**CITY OF GAINESVILLE PLANNING DIVISION
SUMMARY OF COMMENTS**

Petition Number 8SUB-02 DB	Development Review Board
Review Date 5/09/02	Reviewed By Carolyn R. Morgan
Project Name/Description	Blues Creek Subdivision Unit 6-G

Petition No. 8SUB-02DB	Date Plan Rec'd: 4/30/02	Review Type: Stage II Preliminary Plat and Plan Review (Design Plat)
Review For: Development Review Board	Review Date: 5/16/02	Project Planner: Carolyn Morgan

BLUES CREEK UNIT- 6G

SITE PLAN SHOWING TREES

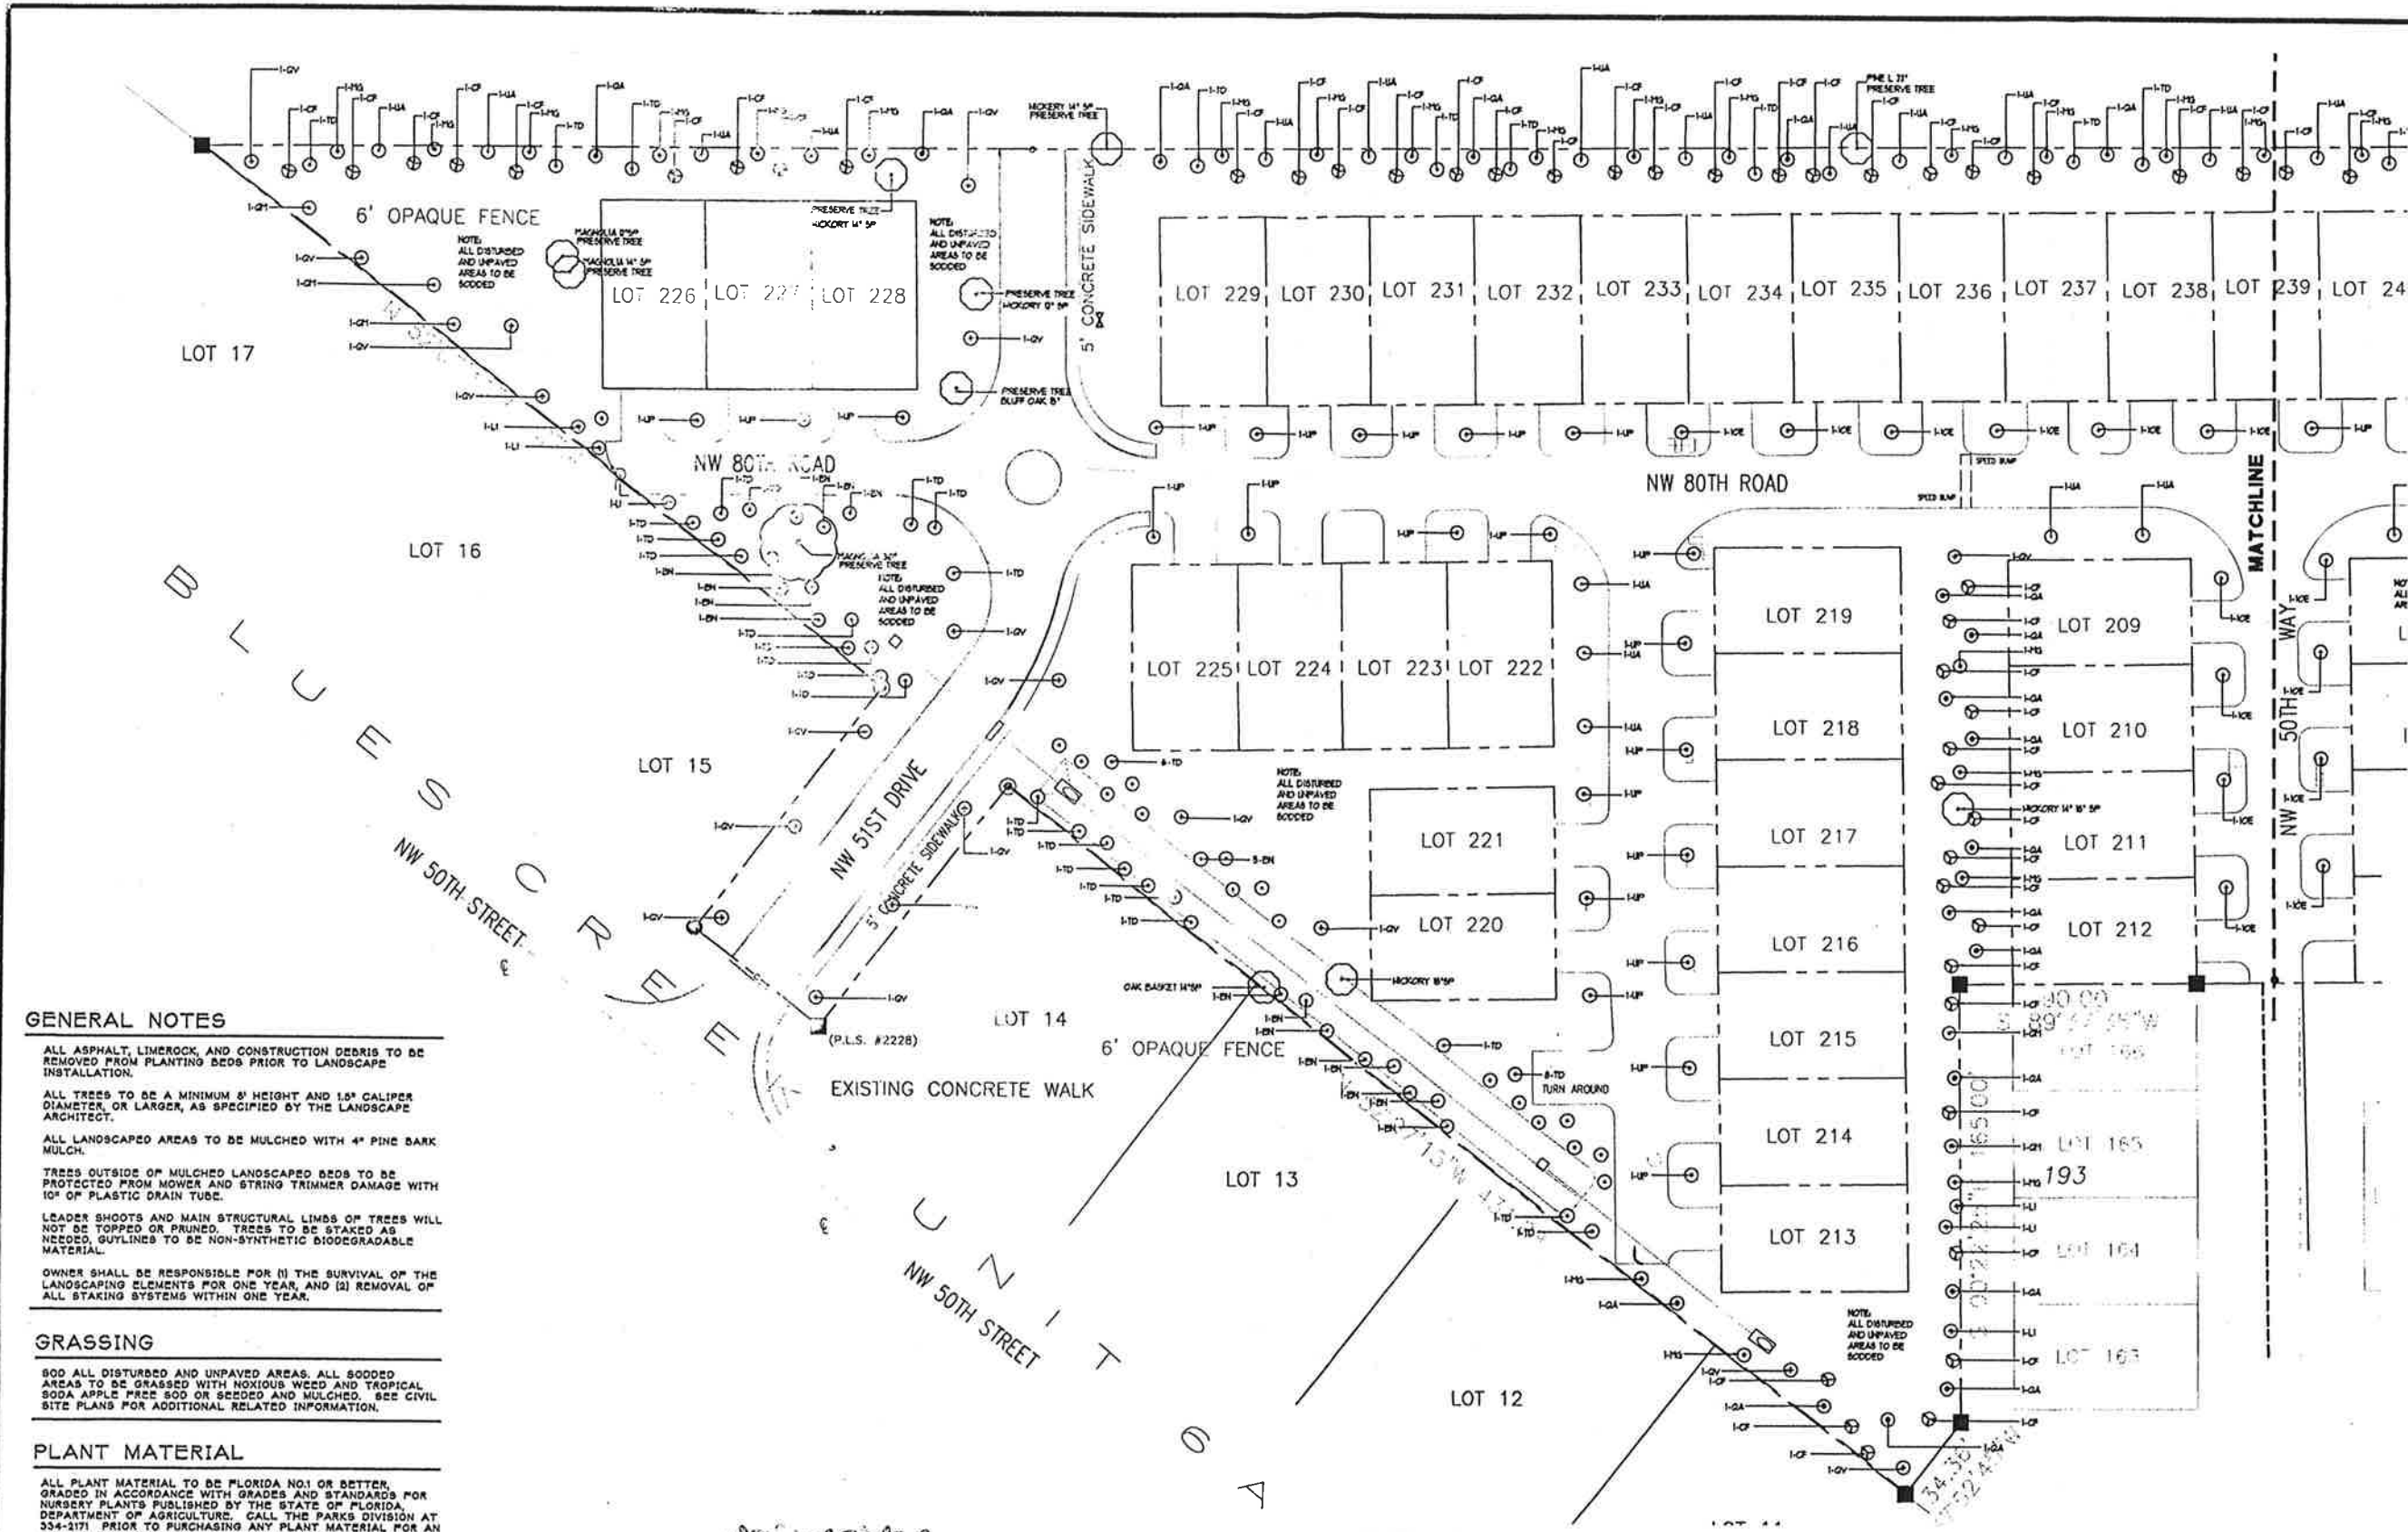
- Put the 11 regulated trees to be preserved on the site plan C-1 (not the site plan showing trees. C-1B).
- Show tree barricades drawn to scale around the trees to be preserved.
- Show barricades around the areas that were labeled as "dense vegetated screen" to keep the soil from getting compacted during construction. The barricades can be removed to work in the area and then can be put back up. This method of working will maintain a friable soil appropriate for supporting vegetation.
- Add the comment to the General Notes:
 "Trees will be preserved on site whenever possible. See the specifications for tree barricades on page ____ . Before beginning any site work, the tree barricades must be inspected and approved by the Parks Division (334-2171.)"
- Put the barricade information alluded to in the preceding comment on the appropriate

--Landscape Plan - I think the site will be too sunny for Flowering Dogwoods. I would change the specification to "American Ash." At the end of construction we can determine which whether the conditions are conducive to Dogwood survival. If they are, we can change the approved site plan to include them.
